RE: SSD 7382 MOD 3 – UTS Central – Response to Submissions

We write with regard to modification application SSD 7382 MOD 3 relating to the extension of Building 1 and the redevelopment of Building 2 (CB02) (otherwise known as UTS Central) at the Broadway Precinct of UTS. The modification request relates to design development changes and includes the following items:

Figure 1 Ausgrid requirements informing the location of the ventilation stack

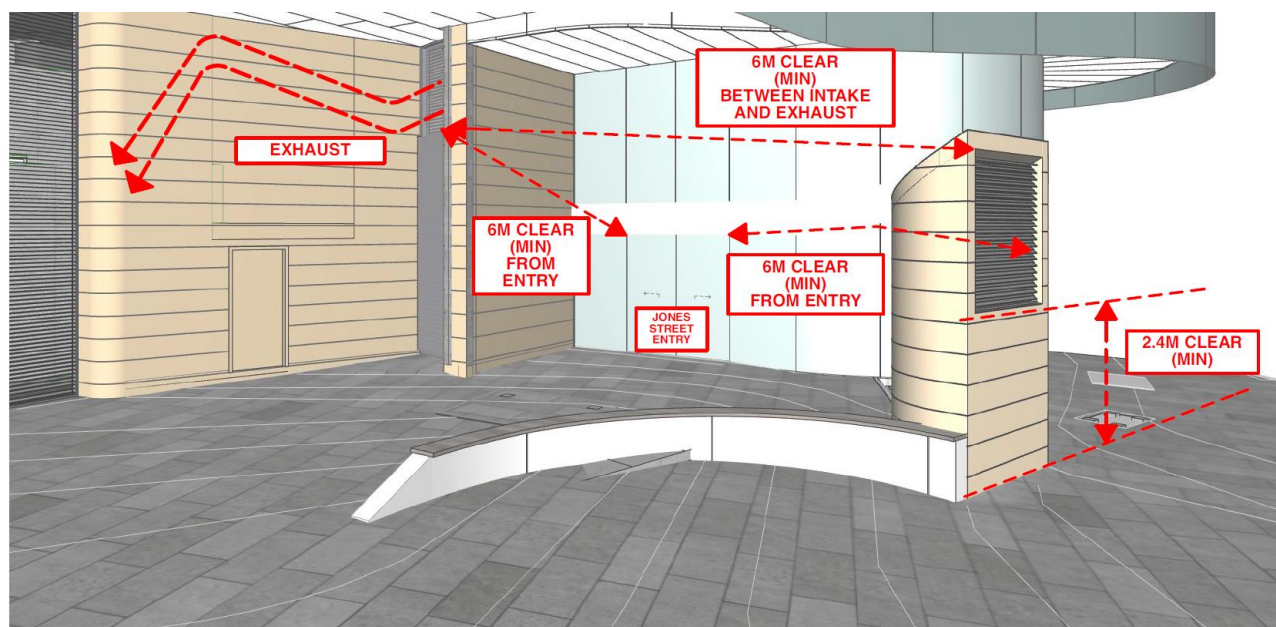
Based on the information provided, concerns are raised that both ventilation shafts are not well integrated with the design of the building. In particular, the stand-alone intake ventilation stack at 5m tall is a prominent and unsightly addition within the public domain. The Department are encouraged to require further investigations be carried out for a more suitable located and/or design for the shafts.

The location of the ventilation stacks is restricted to the proposed location due to relevant Ausgrid requirements, which require clearances between and from both the exhaust and intake for the substation, the entry of the building and the position of the substation below Jones Street (refer to **Figure 1**, with further diagrams demonstrating

substation ventilation requirements at **Attachment A**). A further limiting factor is the location of the substation on level 2 (below Jones street) relative to the boundary on Jones Street, the edge of the UTS Central building above and the existing services (including HV easement) that run between UTS Central and the Broadway Building to the west.

In accordance with Ausgrid requirements, the transformer in the substation cannot be more than 10m from the top of the louvres which sets a maximum vertical distance for where the ventilation stacks are located. There also cannot be less than 6m between intake and exhaust for the substation and no less than 3m between the intake/exhaust and the entry on Jones Street. All these factors together have led to the design approach being adopted.

Figure 4 North (Alumni Green) Elevation

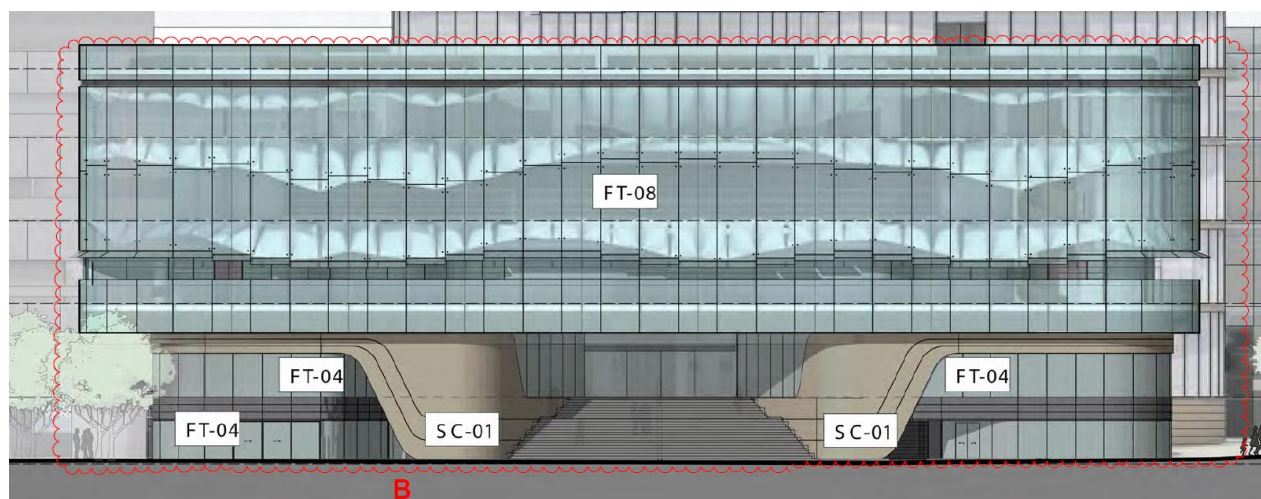
During the response to submissions stage of this modification application, a further change was made to the materials of the façade facing Alumni Green. Under the initial plans submitted with the modification application, the materials of the façade adjacent to the steps fronting Alumni Green were proposed to comprise natural sandstone panels on proprietary sub framing or stub wall. This material has been revised to now comprise paint finish to rendered finish on masonry wall. The area in question is annotated 'SC-01' in **Figure 4** below.

The change in materials is primarily due to buildability and the ongoing maintenance and long term durability of the finish. This facade has also been articulated to have the same dimensional setout of the slab edge fascia of the tower and is also consistent with the facade panel joints on Alumni Green. As outlined above, the material of the substation ventilation shaft on Jones Street match the amended materials on the façade of the building.
